SCHWEIZER SERVICE NOTICE

NOTICE NO. N-183.3*
DATE: 15 Sept 1989
Page 1 of 8

SUBJECT:

- PILOT PREFLIGHT CHECK OF TAIL ROTOR BLADE LEADING EDGE ABRASION STRIP.
- DETAILED INSPECTION OF TAIL ROTOR BLADE LEADING EDGE ABRASION STRIP BONDING.
- INSTALLATION OF RIVETS ON TAIL ROTOR BLADE LEADING EDGE ABRASION STRIP.

FIGURE 1. ABRASION STRIP RIVET HOLE LOCATION

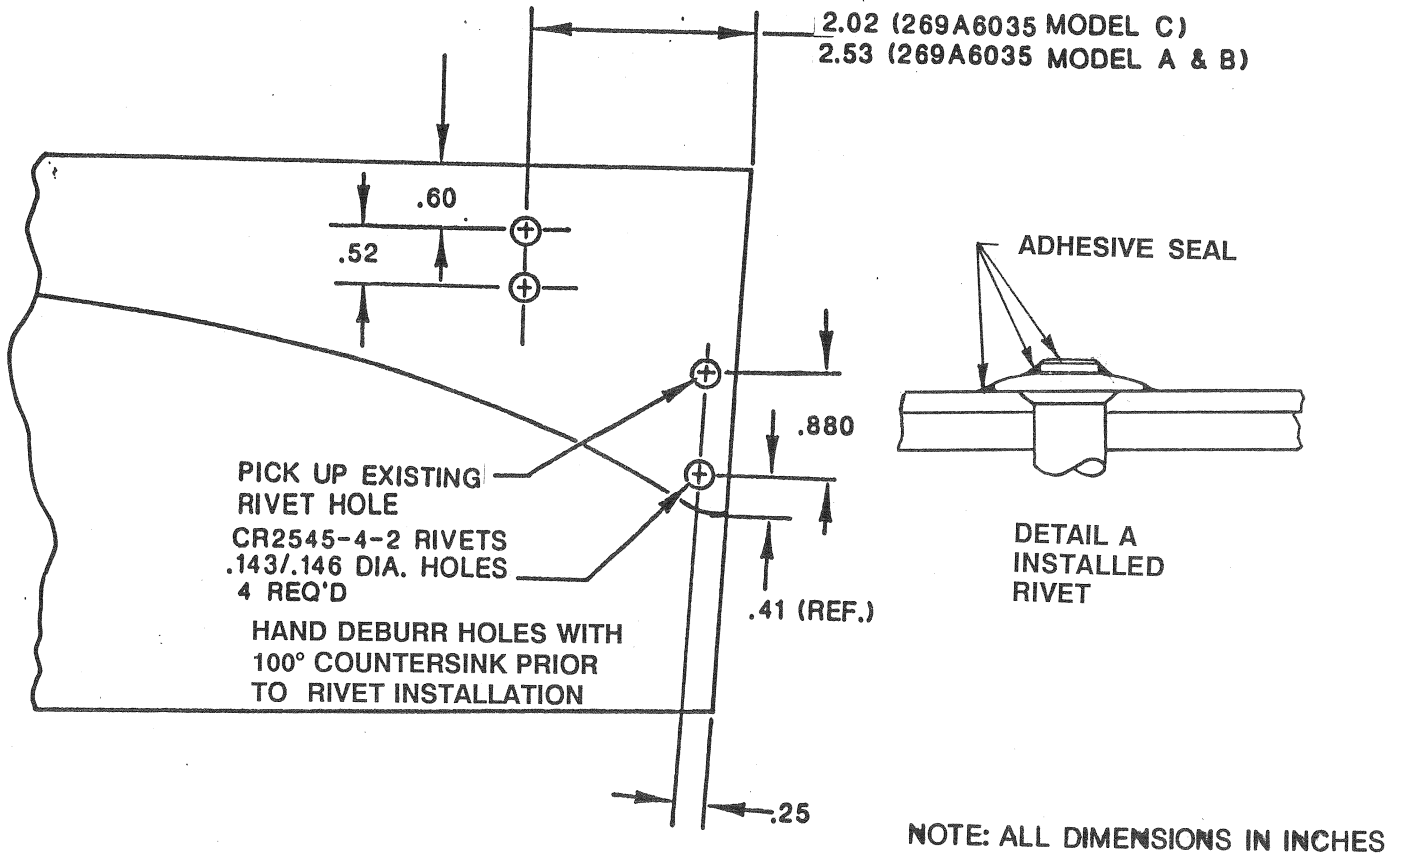
IT IS IMPORTANT TO LOCATE RIVET HOLES EXACTLY AS SPECIFIED IN THE FOLLOWING. FAILURE TO DO SO MAY AFFECT STRUCTURAL INTEGRITY.

- IT IS IMPORTANT TO MAINTAIN ADEQUATE EDGE DISTANCE WHEN DRILLING THE TWO OUT-BOARD RIVET HOLES. LACK OF EDGE DISTANCE WILL WEAKEN THE MATERIAL AND MAY CAUSE CRACKING WHEN THE RIVETS ARE INSTALLED.
 - USE A DRILL STOP TO PREVENT DRILLING INTO OPPOSITE SIDE.
 - TO MAINTAIN PROPER HOLE SIZE AND SATISFACTORY RIVET INSTALLATION, IT IS IMPORTANT TO HAVE BLADE RESTING FLAT ON WORK SURFACE DURING DRILLING AND RIVETING OPERATIONS.
- c. Using a No. 27 Cobalt drill, locate and drill four rivet holes as shown on Figure 1.
- d. Hand deburr rivet holes using 100° countersink.
- e. Using epoxy adhesive, wet install four CR2545-4-2 rivets. (Allow adequate drying time prior to performing step h. below.)

- g. Remove defective rivet(s) as follows:
- (1) Carefully grind off locking collar and upper portion of rivet stem.
 - (2) Using a drill stop, drill through rivet stem using care to prevent hole enlargement.
 - (3) Push remaining rivet stem (with sheer ring) from hole, and remove from spar.
 - (4) Inspect hole in spar. If defective, consult SAC.
 - (5) Return to step d. above and install new rivet(s).
- h. Coat the exposed rivet heads with epoxy adhesive. Ensure that stems and rivet head edges are sealed, but do NOT apply excessive adhesive. (See Detail A, Figure 1.) Also ensure that adhesive is smooth without voids.
